**Town of Brookfield**  
645 N. Janacek Road  
Brookfield, WI 53045  
(P) 262-796-3788  
(F) 262-796-0339

### PLAN COMMISSION

### AGENDA

## TOWN OF BROOKFIELD PLAN COMMISSION ZONING REPORT

**OSCAR'S FROZEN CUSTARD  
 TOWN OF BROOKFIELD  
 SITE PLAN**

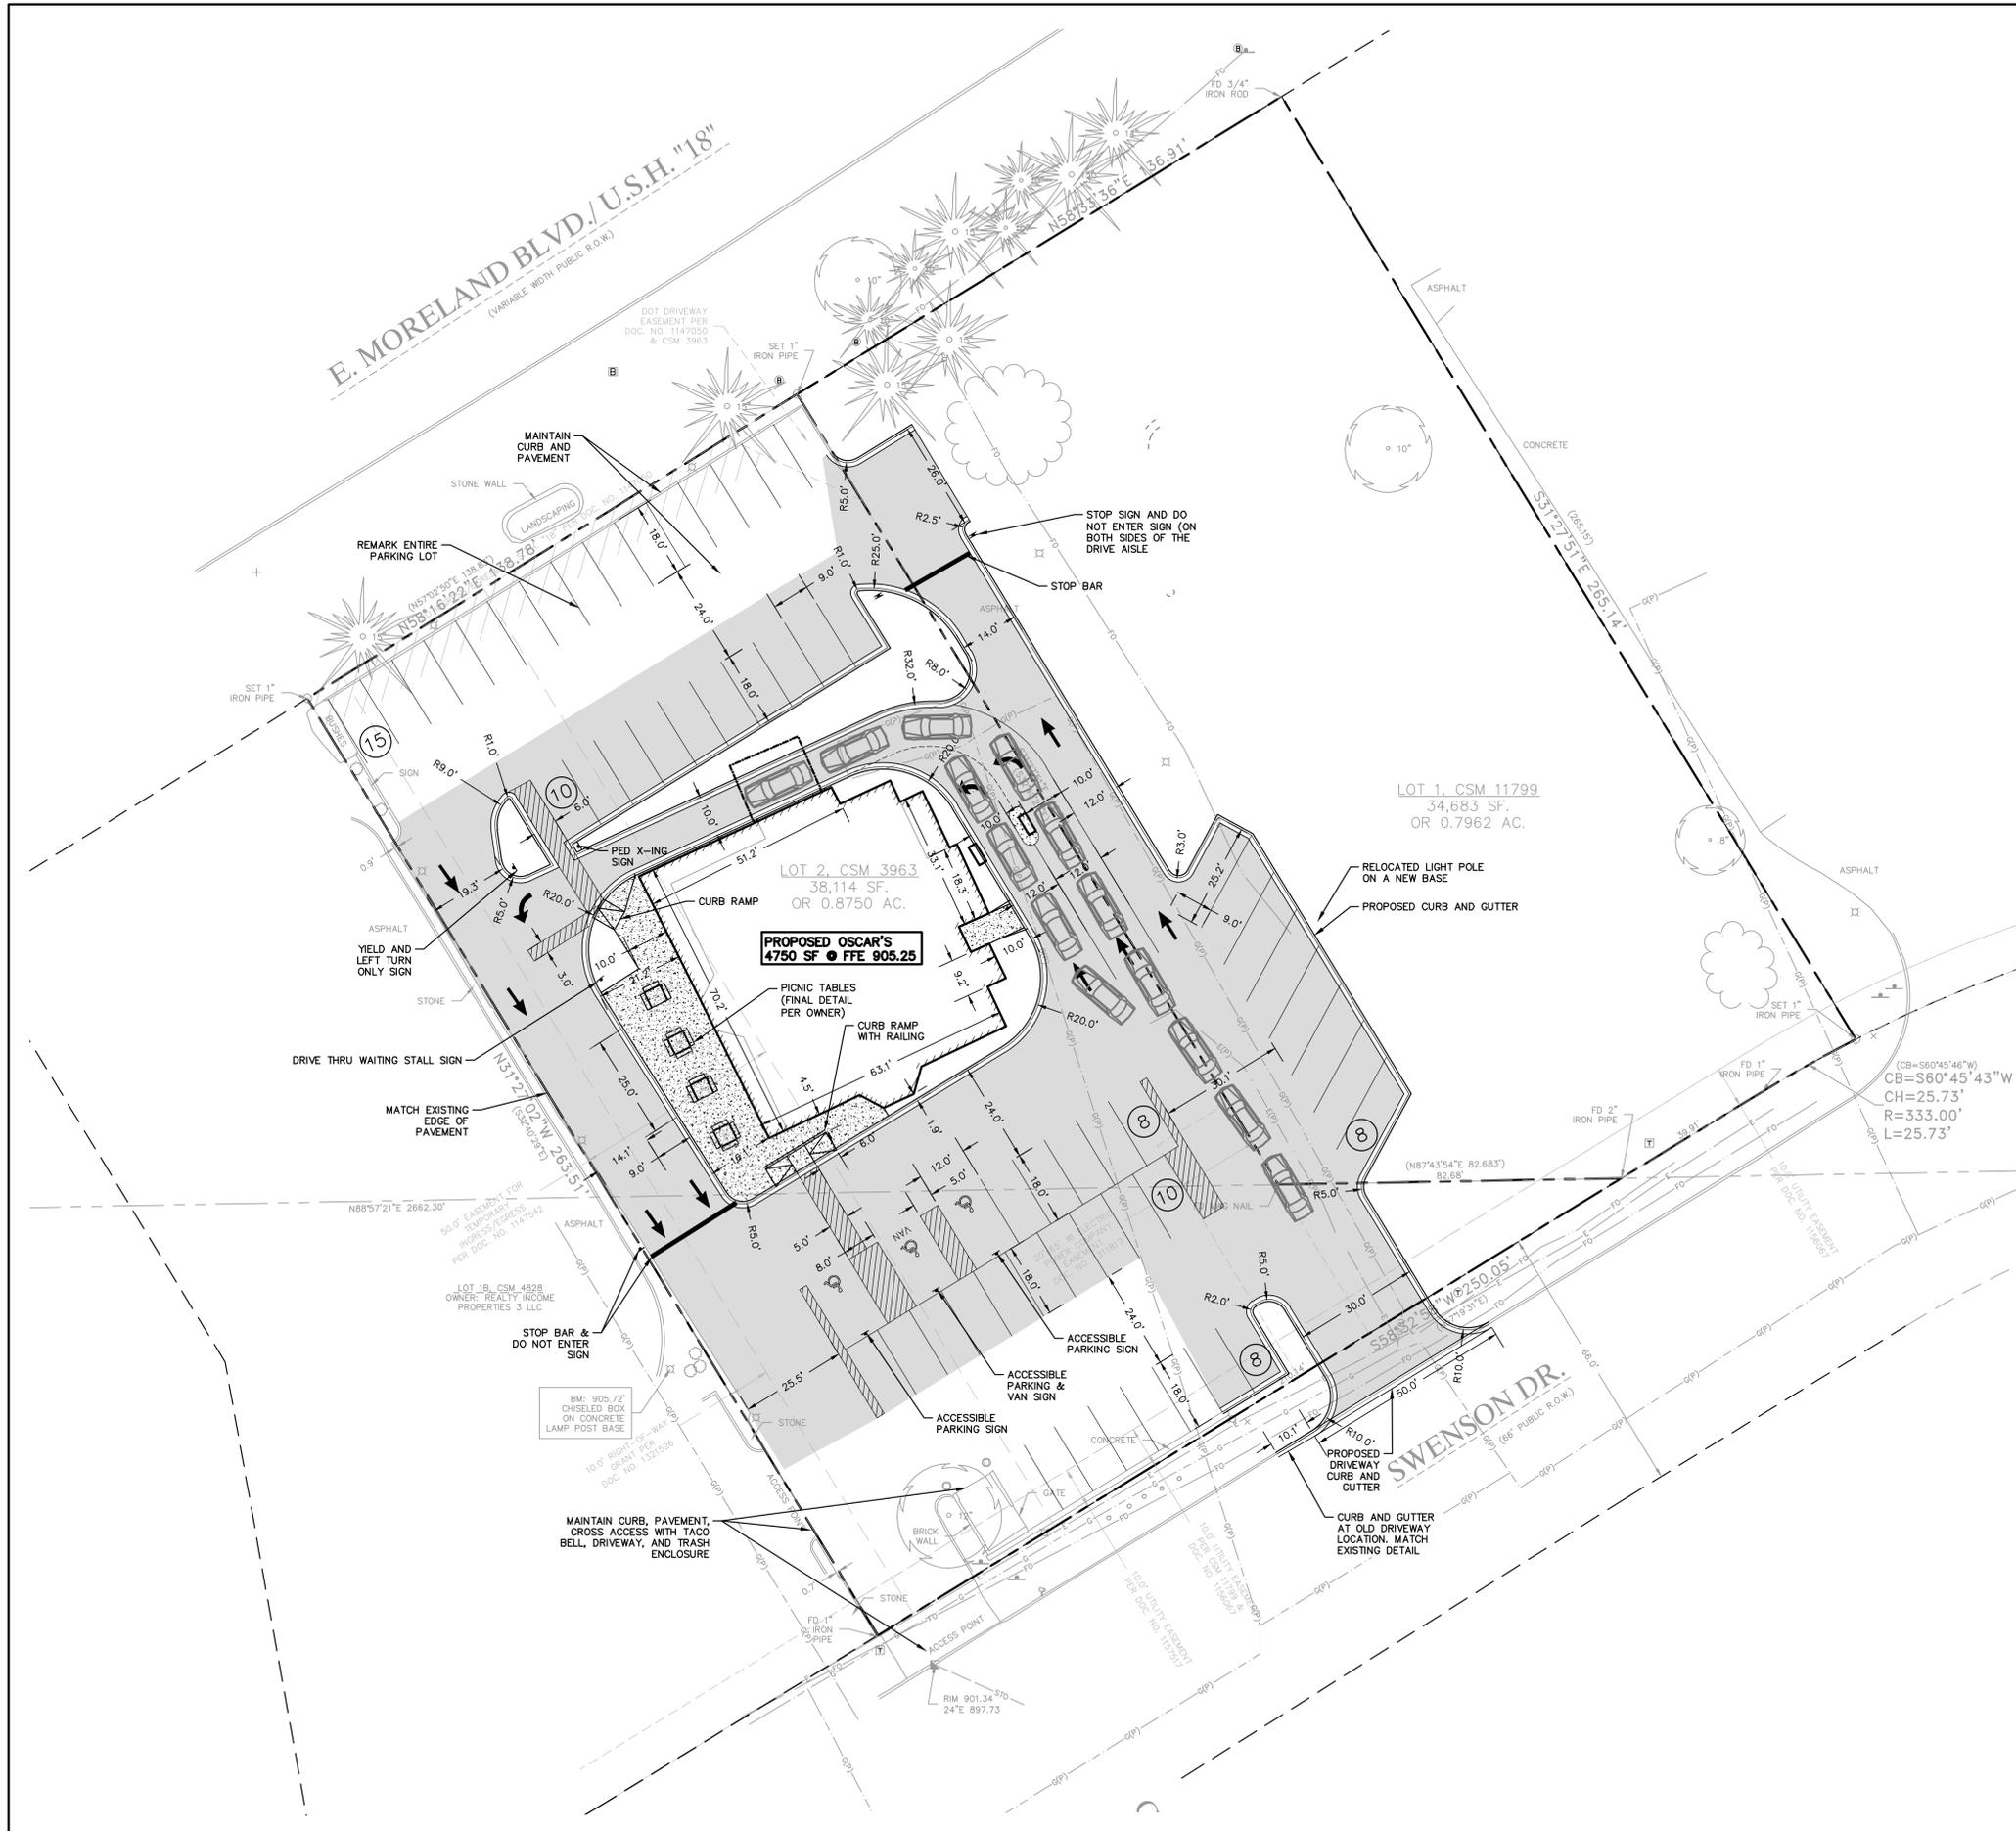
- The site plan shows a potential access connection on the northeast side of the property.
- Drive-through lanes
  - The site plan shows 2 drive-through lanes and 1 pickup window. Generally, a stacking length of 100 feet is desirable and 40 feet of distance between the pick up window and the access drive is preferred. Overall, it looks like sufficient stacking length is provided.

AVERY & BIRCH SALON SUITE FACILITY  
 TOWN OF BROOKFIELD, WI  
**PRIVATE SANITARY SEWER AND WM PLAN**

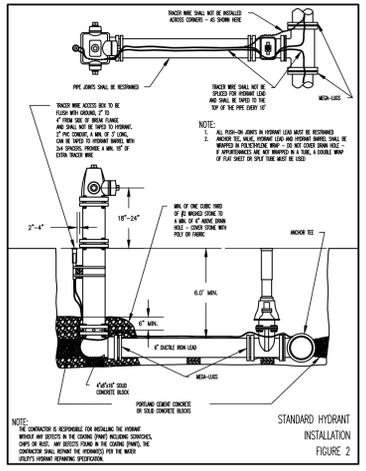
- According to our records the existing water service in Crossroads Cir is 6", they are proposing connecting a 8" watermain to it. So the existing service will need to be abandoned and tap a new 8" tee and valve or the existing 8"x6" Tee be replaced by a 8"x8" Tee. Either way the watermain will need to be turned off to abandon the existing 6", the neighboring office buildings will need to be notified and this may need to be completed at night. The existing watermain is in the street so street restoration and traffic control should be added.

- The proposed 8" watermain and hydrant will become public, it should be noted and I believe a DNR approval will be needed.
- The "Hydrant Installation Figure 2" specifies a Ductile Iron Lead, we allow PVC.
